Notice of Rezoning Bylaw

Meeting Date: **March 17, 2025**
Subject Properties: 9099, 9107 & 9111 Cedar Street
Planning File: R22-045

Project: P2022-104
Application Numbers: R22-045, DP22-127, DV22-027

Subject: Development Application at 9099, 9107 & 9111 Cedar Street – Introduction Report

Attachment A – Site Plan

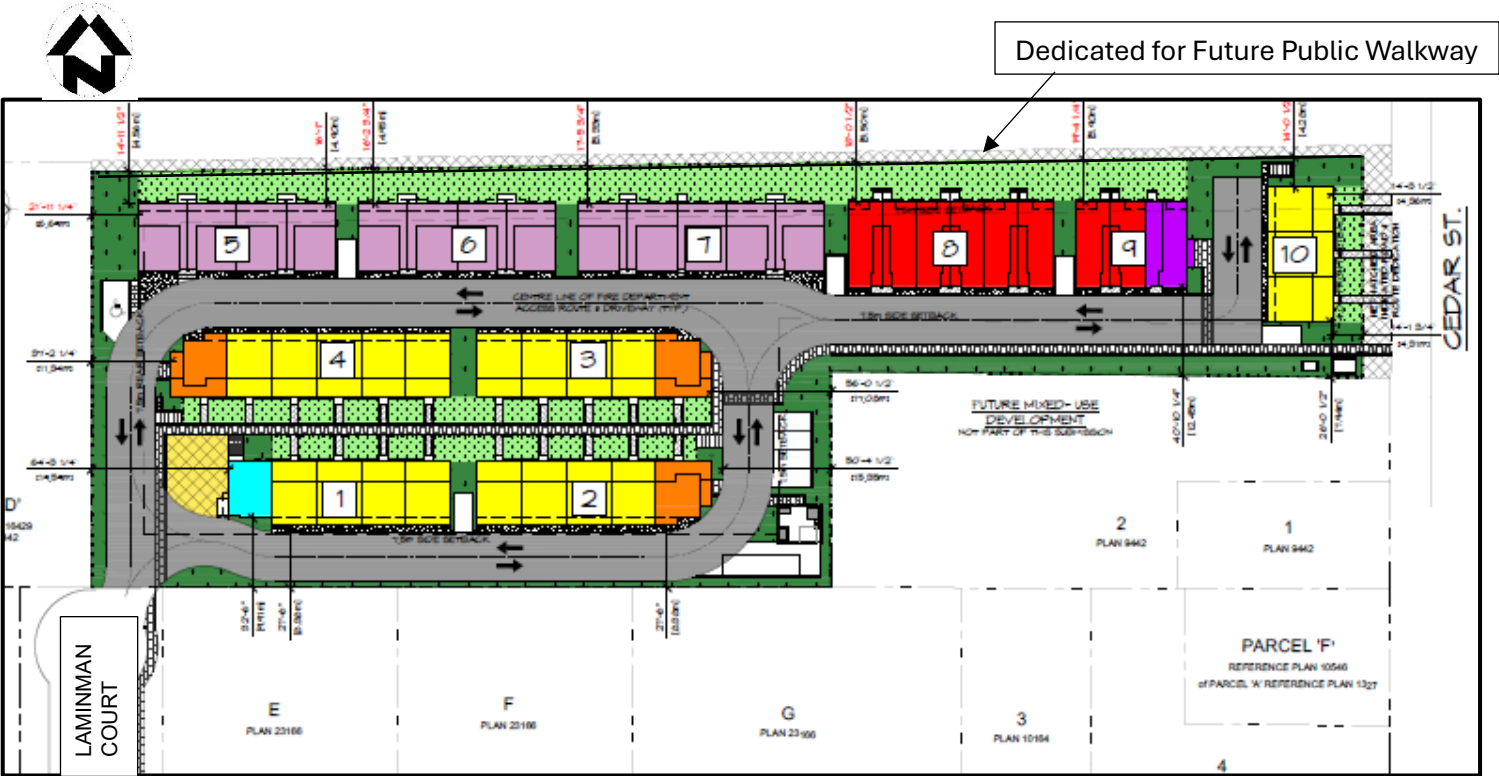
Mission Fire Rescue Service: The vehicle entrance on the southwest corner of the development appears sub-standard. The developer is to confirm the configuration will meet the turning requirements outlined in the Development and Subdivision Control Bylaw, when turning east into the development from the entrance to the site.

Staff are not generally supportive of the request to reduce stall width from 3.0 m to 2.6 m as requested in Table 3, item 2. A reduction in stall width will impact the function of the stall, and this is a green field development site that should be designed to accommodate the basic requirements. The applicant has been encouraged to amend the site plan to accommodate the required parking.
